FW: Request for Additional Information Needed for SEPA Threshold Determination

Windhaven AM Synchro-SimTraffic Results Comparison.pdf

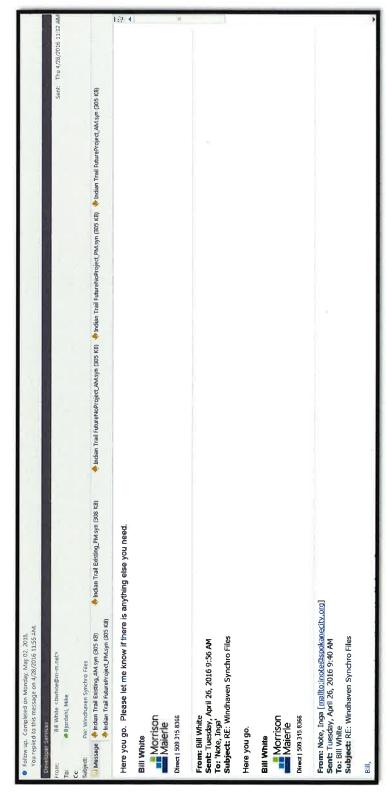
- 2. To see the difference between Synchro HCM 2010 and SimTraffic signalized intersection results, the AM and PM Synchro models were run (models as received from Bill White on 4/28/2016) and the results are attached. The only intersections reported were the relatively uncongested ones since the congested ones, i.e., Alberta, Maple, and Ash, produce unreliable results due to signal timing coding errors and O/D weighting that needs corrected at Maple/Ash/Francis.
- 3. Another option for verifying delay is by doing a field measurement at the congested intersections to measure what the delay is.
